STAFF REPORT: OCTOBER 11, 2023 MEETING PREPARED BY: A. DYE

APPLICATION NUMBER: HDC2023-00024

ADDRESS: 2244 WABASH

SCOPE: DEMOLISH REAR OF HOUSE* (WORK COMPLETED WITHOUT APPROVAL);

4 BSEED Dangerous Buildings Division site visit photo, November 14, 2022.

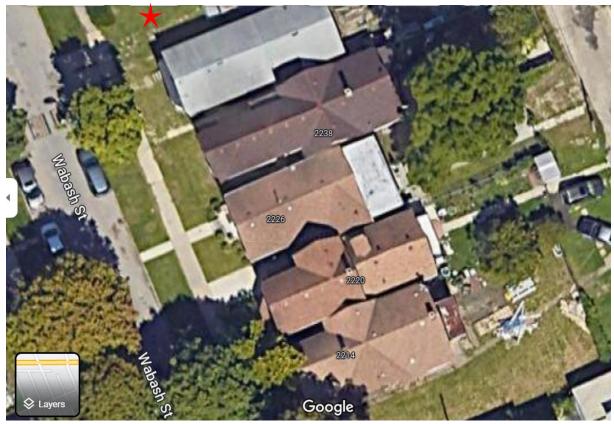
Staff obtained photos from BSEED's Dangerous Buildings Division that show the condition of the rear wall prior to the recent demolition of the rear section of the house. This view shows the historic gable's wood sheating and rake board were intact. Staff believes this section of the house could have had temporary support while the structural issues were corrected.

1897 Sanborn map. 2244 Wabash is highlighted. Photos on this page were taken by staff, standing at Wabash sidewalk.

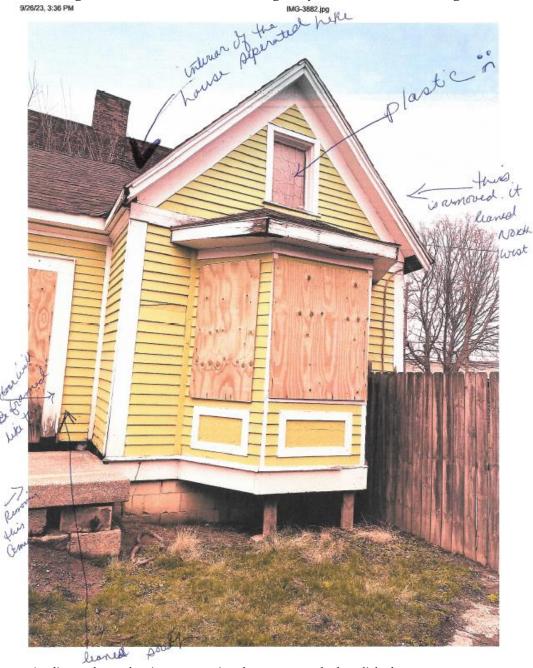
On the following page is an expanded view of the 1897 Sanborn map which shows that neighboring five dwellings had inset or extending walls and all but one had (and still have) cross gabled roofs.

Google aerial image. 2244 Wabash is not visible but is directly above where the star is located. This view shows how four of the five houses have cross gable roofs, many of which cover extending walls (identical to what was in place at 2244 Wabash). The photos on the following page offer streetscape views of the above dwellings.

Applicant photo, showing rear section that was recently demolished.

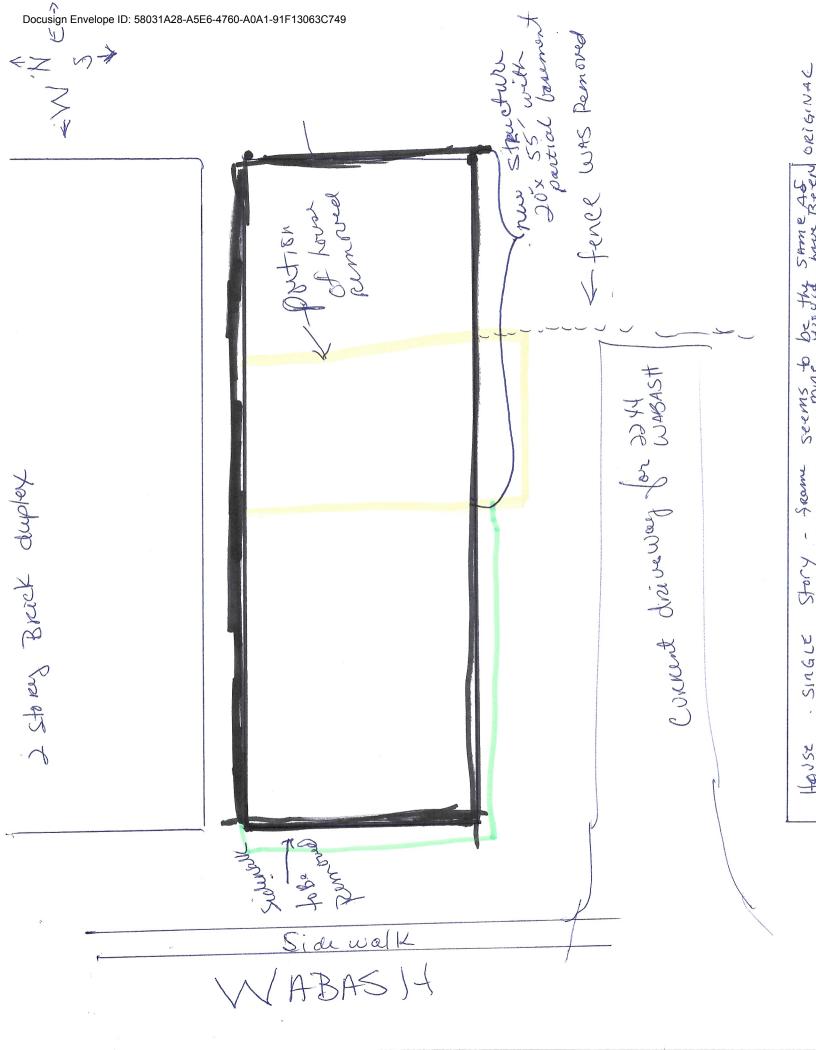
• While the rear portion of the house, shown in the below photo, may have had structural issues, this section of the dwelling could have been stabilized or rebuilt to retain the historic footprint. It is staff's opinion that the smaller pre-1921 extension that had a lower shed roof (as seen in the designation photo on page 3) was not a distinctive character-defining feature of the dwelling. Therefore, erecting a rear addition in that location might meet the Standards and achieve the additional square footage desired by the applicant while retaining the distinctive character-defining footprint of the 1884 dwelling.
